Project Reading Metropolitan
LPA ref 182252
From Francesca Whitfield/Adrian Cole
Date 19 July 2019

Transport Addendum

Table 1: Response to comments raised by Reading Borough Council's Transport Development Control Group

Drawing No. 23061101-SDG-HGN-100-DR-D-01008

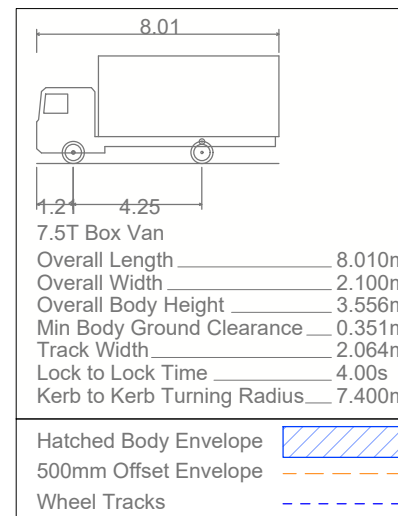
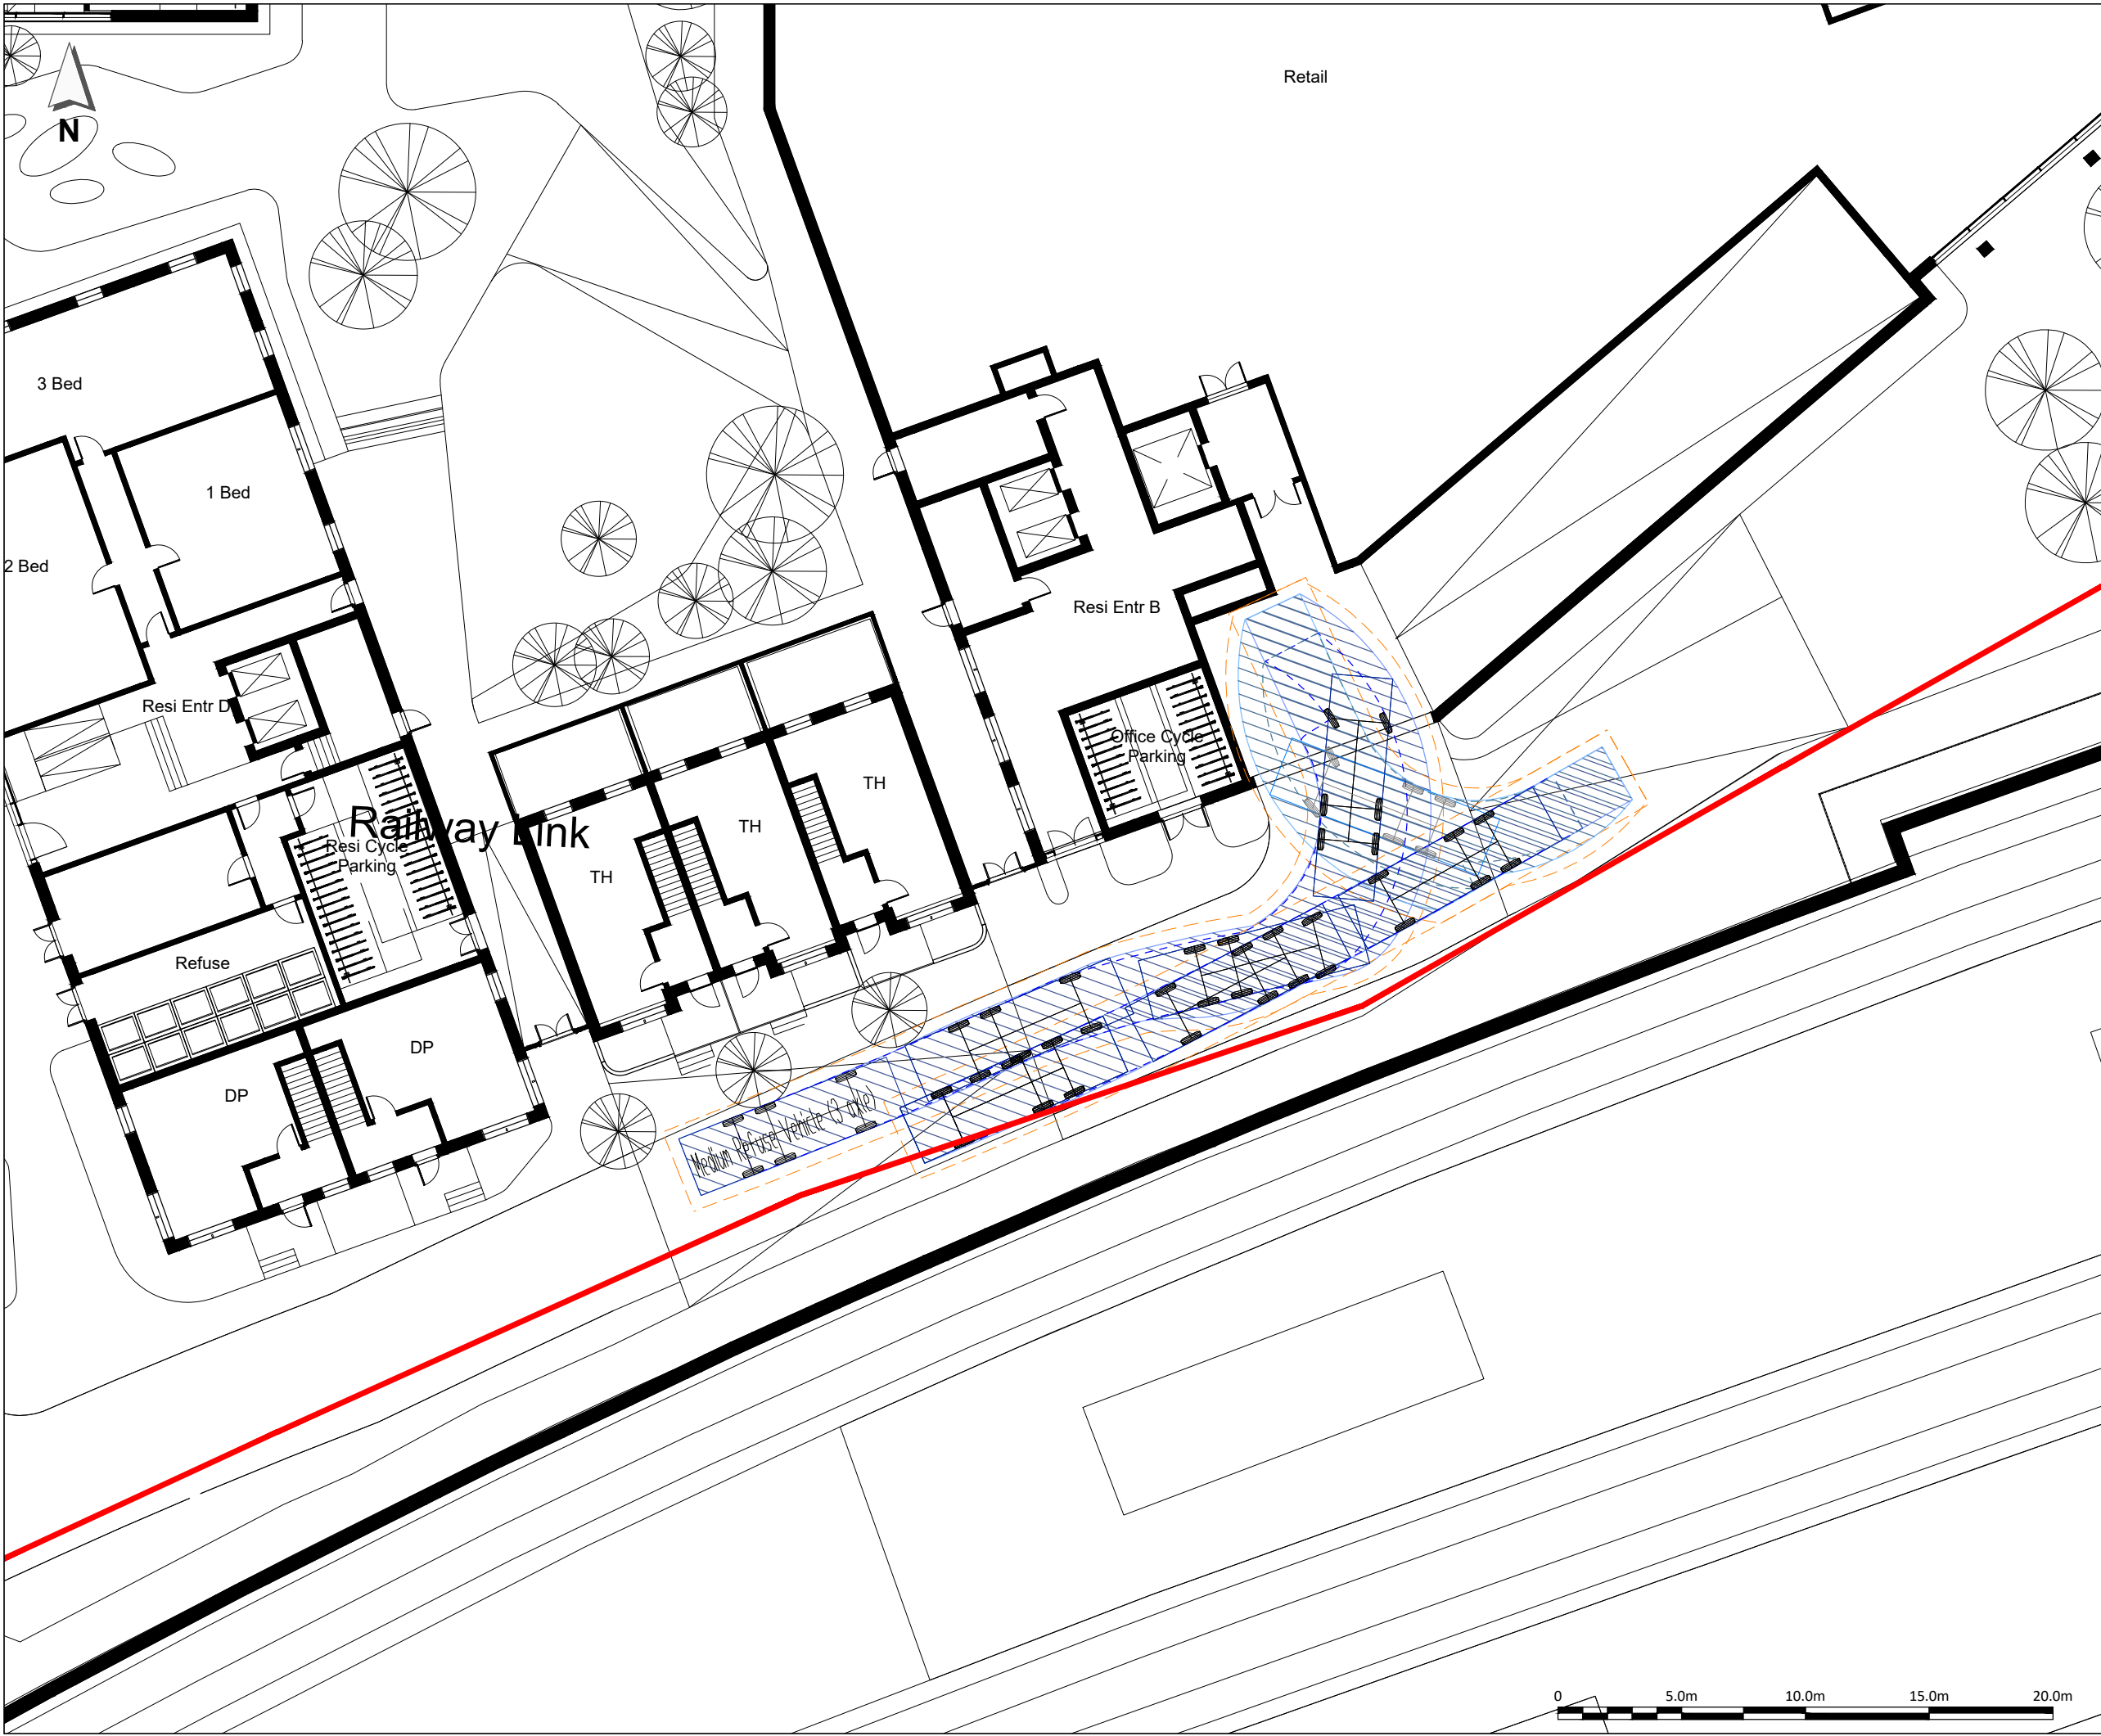
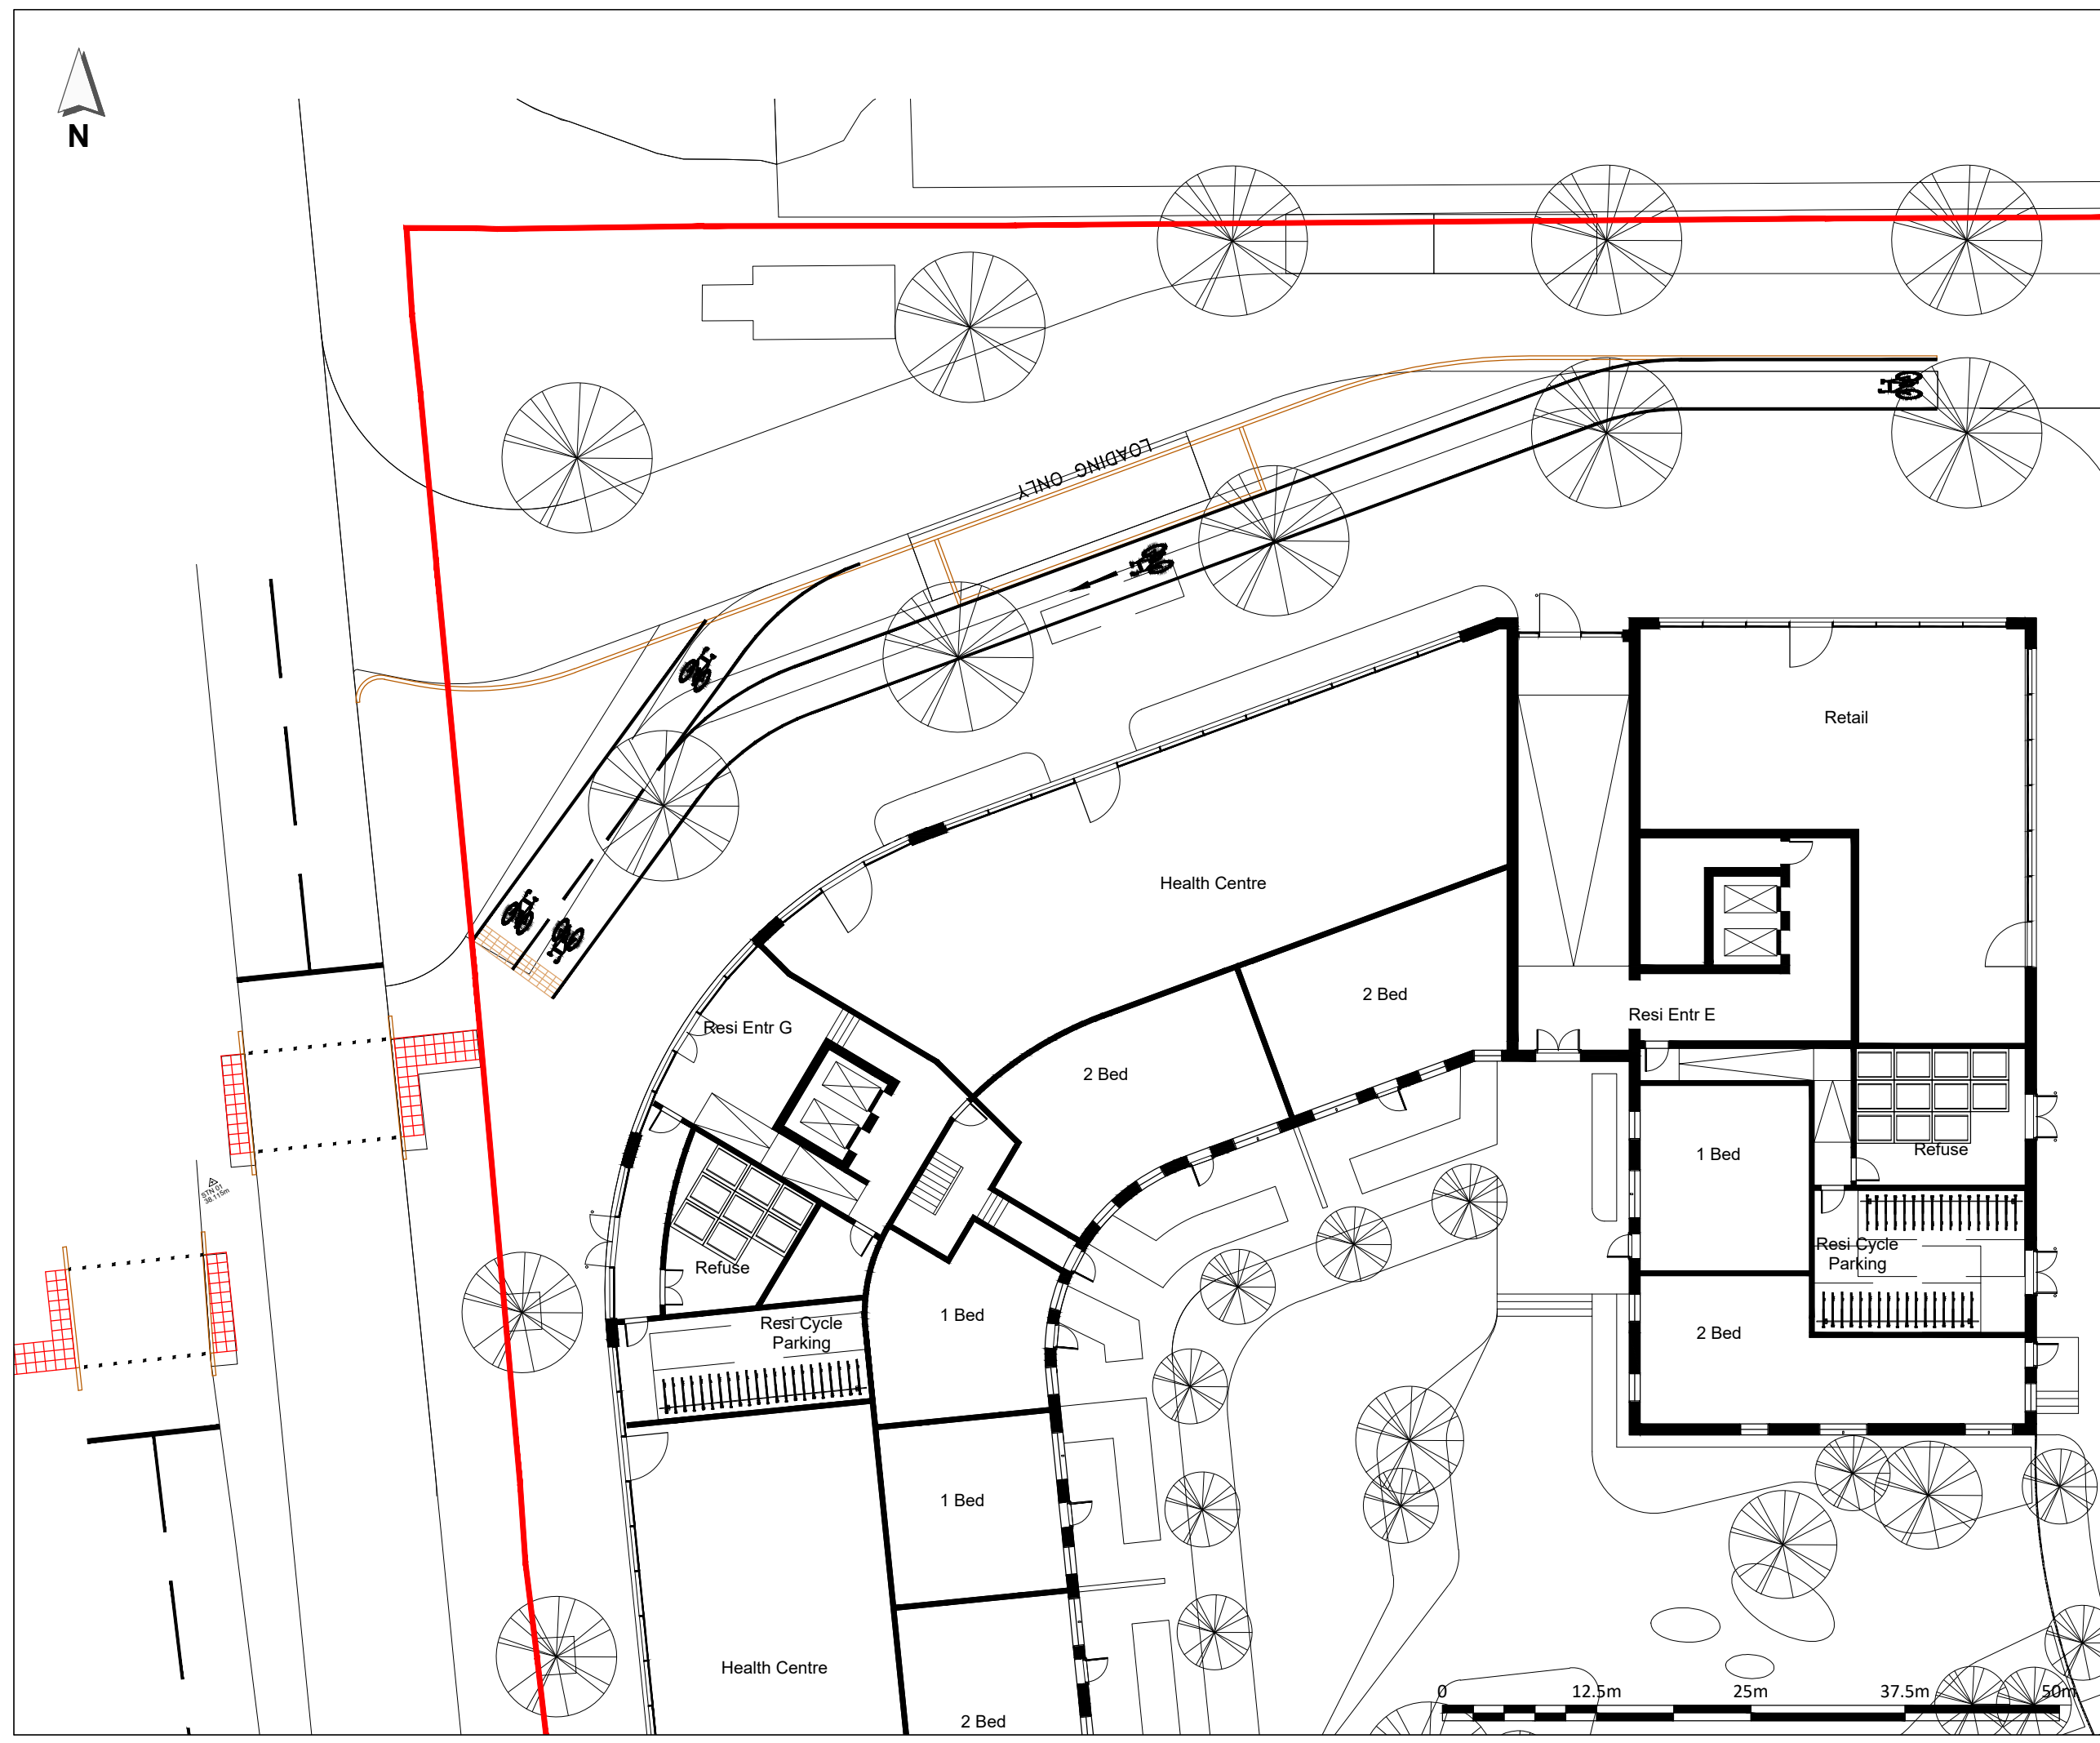
Site Access	The western access was previously the subject of a safety audit given the close proximity to the access to the adjacent site, given that the junction design has not altered, the flows generated by the development and the surrounding Highway flows have reduced I am happy that another safety audit at this stage would be required. If the application were to be implemented further safety audits would be required in accordance with National Guidance.	We have read this comment as “would <i>not</i> be required”. A Stage 2 safety audit would be undertaken at detailed design stage.
	Tracking diagrams have been submitted that confirm that vehicles will be able to enter and exit the site in forward gear and this is deemed acceptable in principle. However, no tracking diagrams have been submitted illustrating vehicles entering and exiting the application site from either point. These should be included to ensure that the access design is appropriate. The requirement for further tracking is also discussed within the servicing section.	Please refer to Steer Drawing 23061101-SDG-HGN-100-DR-D-01008, located in Appendix B, which shows various tracking manoeuvres.

The internal road running north to south is only 4.5m in width, given that this is to accommodate service and refuse vehicles this must be a minimum of 4.8m in width in accordance with manual for Streets. The gradient to the basement car park should also be stipulated to confirm that it meets with standards.	Please refer to the updated site layout plan (TP Bennett drawing A11113 C 2 100 Rev P7), located in Appendix A . The road width has increased to 4.8m.
	An existing access currently exists to the south west corner of the site and this is to be retained as an access to Network Rail but will be restricted access through bollard control. It should therefore be confirmed what the exact use of this access will be and what type of vehicle will utilize the access. The set back of the bollards should ensure that vehicles waiting to access the site are not protruding onto the footway.	Access to this road from Caversham Road will only be provided to Network Rail vehicles as and when required. Please refer to the swept path (drawing ref 23061101-SDG-HGN-100-DR-D-01008 Sheet 2) in Appendix B. This demonstrates that vehicles with a length of up to 8m are able to wait for entry without obstructing pedestrian movement. Furthermore, vehicles with a length of up to 10m can wait for entry without obstructing vehicles using the nearside southbound land on Caversham Road. We do not expect vehicles above 10m to use the Network Rail access point.

Servicing	Swept path analyses has been undertaken and included within the TA for a delivery vehicle and this is for a 7.5 tonne vehicle however Point 7.8 of the TA stipulates that 'Servicing and delivery vehicles (<7.5 tonne and/or 10m Rigid HGV vehicles) are proposed to enter the site via access junctions at Vastern Road (Plots 1 and 2) and Caversham Road (Plot 3 and the western service yard for Plot 2)'. Given this additional tracking diagrams are required to incorporate the larger anticipated vehicles. Tracking diagrams are also required identifying that vehicles can enter and exit each service / delivery bay.	Please refer to the swept paths (Steer Drawing 23061101-SDG-HGN-100-DR-D-01008 Sheet 3 & Sheet 5) located within Appendix B. These drawings demonstrate that a 10m rigid vehicle is able to enter the site and access the service/delivery bays.
	Point 4.30 states that 'No servicing will be undertaken from nearby public highways, such as Caversham Road' however refuse stores and commercial units are accessed directly from Caversham Road which will only encourage on street servicing. The closest bay would be between 26m and 54m and this is from a bay which conflicts with the cycle route located to the north east of the site, any relocated bay is therefore likely to be located further from this point.	The closest servicing bays are located on The Avenue, located to the north of blocks G and H and outside the office building on the access road adjacent to the railway. In order to ensure that no servicing will take place on Caversham Road, refuse stores that are accessed directly from Caversham Road will be subject to a waste management strategy, where refuse is moved to the closest servicing bay prior to collection times.

It is noted that a commercial unit is located in the south west corner of the site however there are no servicing / delivery bays provided to the south of the site. It should therefore be confirmed where this unit would be serviced from.	Please refer to the updated site layout plan in Appendix A . This unit will be serviced from the access road adjacent to the railway. The tracking in Appendix B (drawing ref 23061101-SDG-HGN-100-DR-D-01008, sheets 5 & 6) demonstrates that a vehicle with a 10m length is able to serve the unit using the turning head.
